# Nofs Garments Ltd

14 August 2022

# Observations

Concrete cylinder test report for column

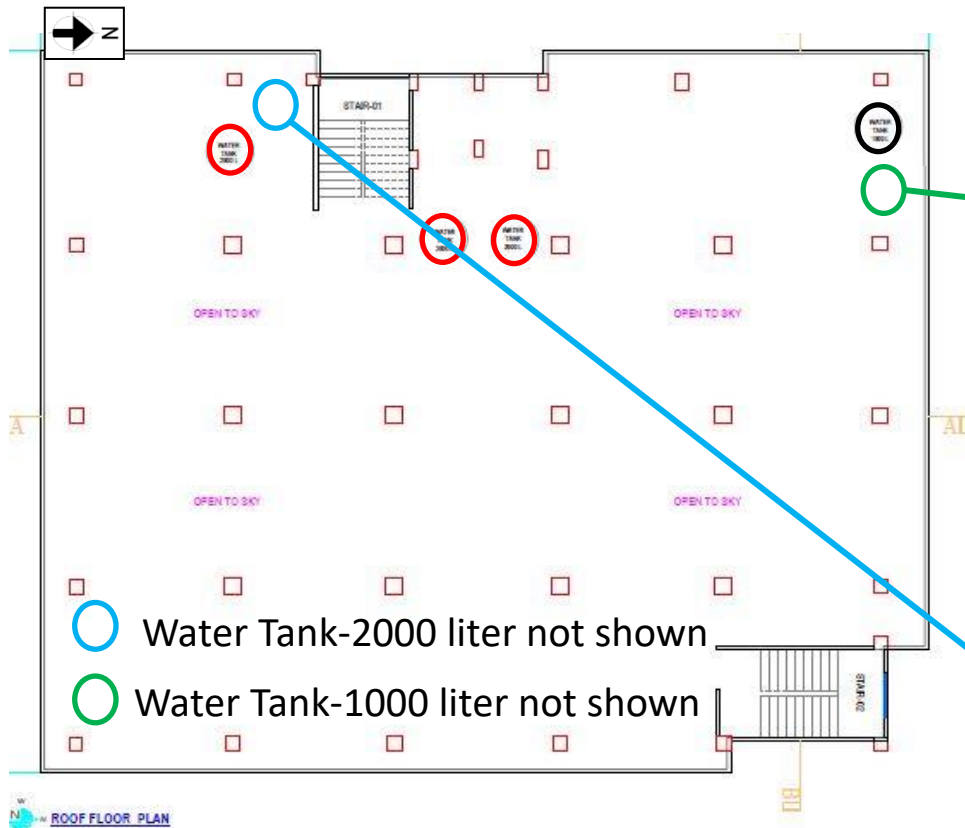
Concrete strength of column is considered as 27.5 MPa in the design report. However, at the time of inspection, only 3 cylinder test report was available from column which doesn't comply the frequency of testing requirement of BNBC (chapter-5). Building engineer is required to verify in-situ material strength and revise the design report accordingly.

Roof layout

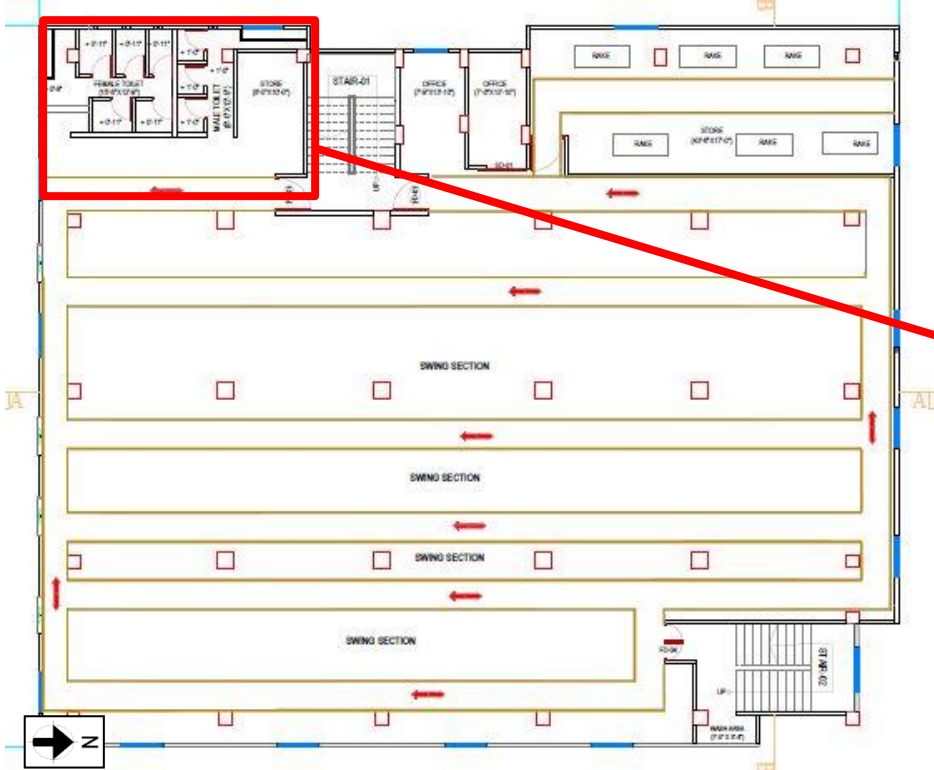
One plastic water tank of 2000 litre capacity and one plastic water tank of 1000 litre capacity were not shown in roof layout but found onsite. Building engineer is required to update the as-built drawing.

Water tank (1000 liter) not shown

Water tank (2000 liter) not shown

Dimension of internal toilet wall not shown in as-built drawing

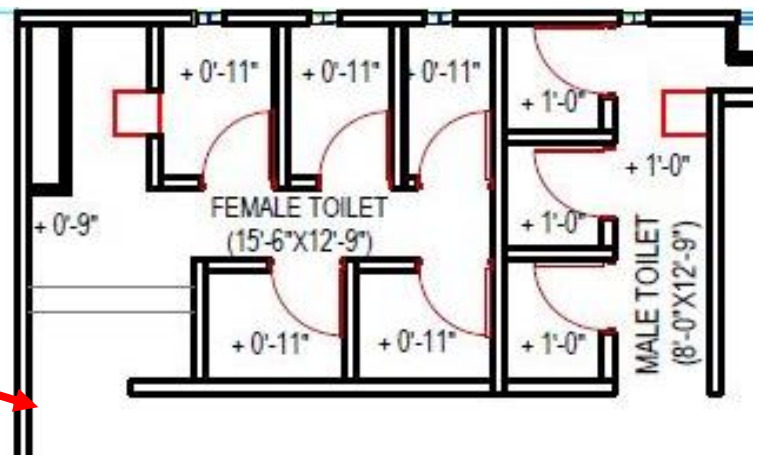
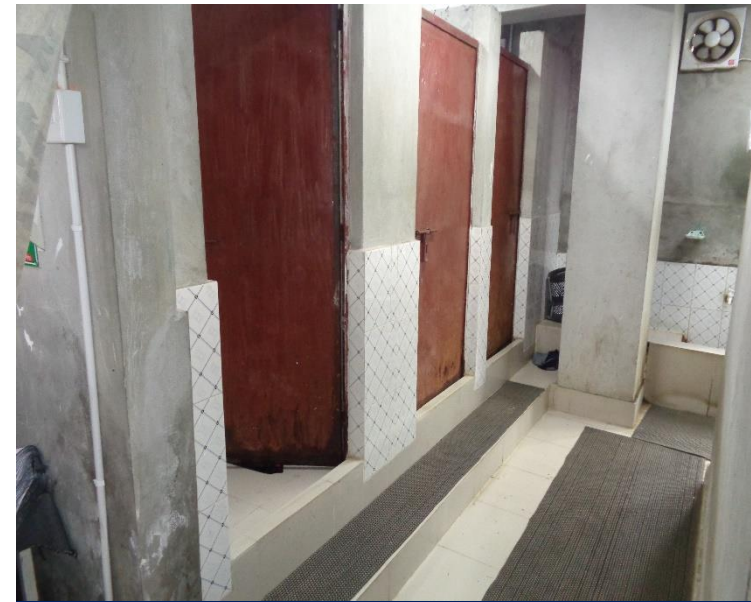
Dimension of internal brick partition wall at toilet areas is not shown in as-built architectural drawing. Factory engineer is required to update the as-built drawing showing dimension of all toilet partition wall.

Apparently inadequate connection

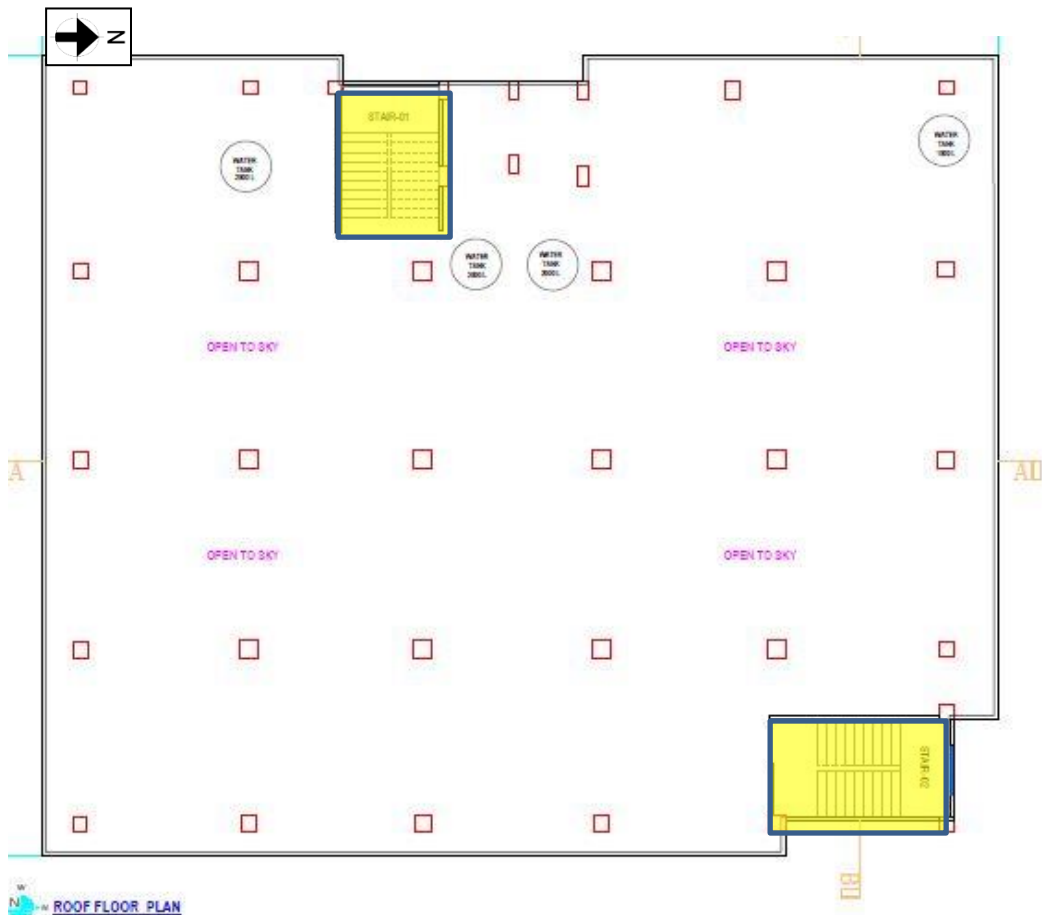
At stair roof, rafters were observed as inadequately anchored with brick wall which were appeared to be inadequate for uplift forces. Building engineer is required to check the connection adequacy for uplift forces as part of EA.
